**REVISED TENTATIVE  
SITE CLEANUP REQUIREMENTS ORDER**

**CALIFORNIA REGIONAL WATER QUALITY CONTROL BOARD  
SAN FRANCISCO BAY REGION**

REVISED TENTATIVE ORDER NO. R2-2013-XXXX

GUADALUPE MINE  
GUADALUPE RUBBISH DISPOSAL COMPANY, INC.  
SAN JOSE, SANTA CLARA COUNTY

**Figure 2. Storm Water Collection and Flow to Creeks**

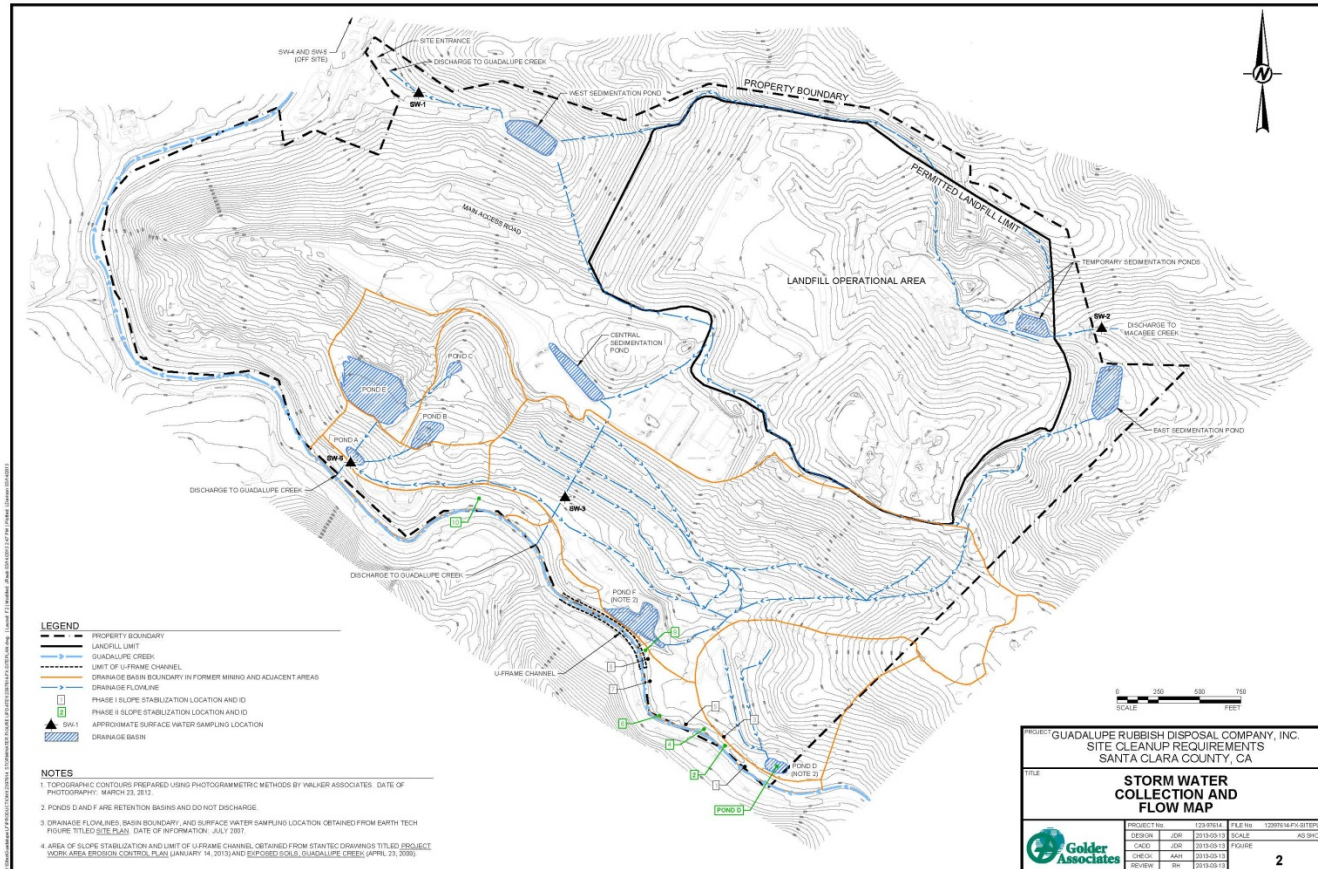
- (c) Revised figures of Stormwater Collection and Flow to Creeks (Figure 2 herein) and Former Mining Operations, Waste Piles, and Facilities Map (Figure 3 herein).

- (i) Figure 2 must be revised to indicate (a) drainage conveyances and pathways for the entire property, including the northwest portion of the Site, and (b) 300- foot-long stretch of mining waste in Guadalupe Creek downstream of U-frame channel (refer to *Mercury Mine Waste Erosion Inventory: Rancho De Guadalupe Area Sierra Azul Open Space Preserve*, Revised, April 2011 available at [http://www.waterboards.ca.gov/sanfranciscobay/water\\_issues/programs/TMDLs/guadalupe/rivermercurytml.shtml](http://www.waterboards.ca.gov/sanfranciscobay/water_issues/programs/TMDLs/guadalupe/rivermercurytml.shtml)); and

**Figure 3. Former Mining Operations, Waste Piles, and Facilities Map**

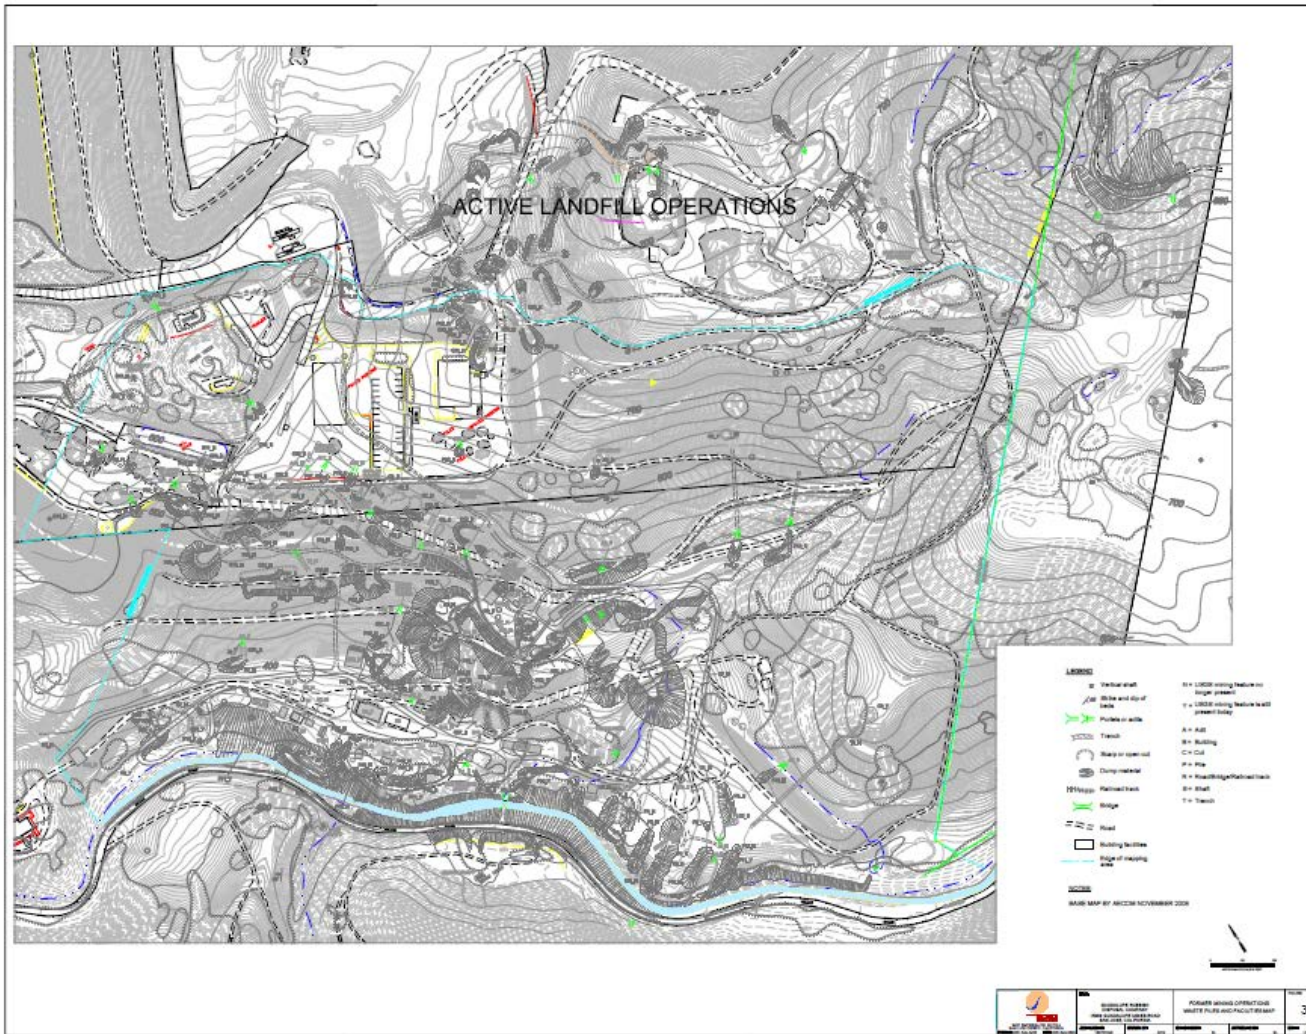
- (ii) Figure 3 must be revised to indicate (a) U-frame channel, (b) 300- foot-long stretch of mining waste from 2(c)(i)(b), and (c) furnace yards (refer to Slide 15 in Michael Cox's letter dated 29Aug2012).
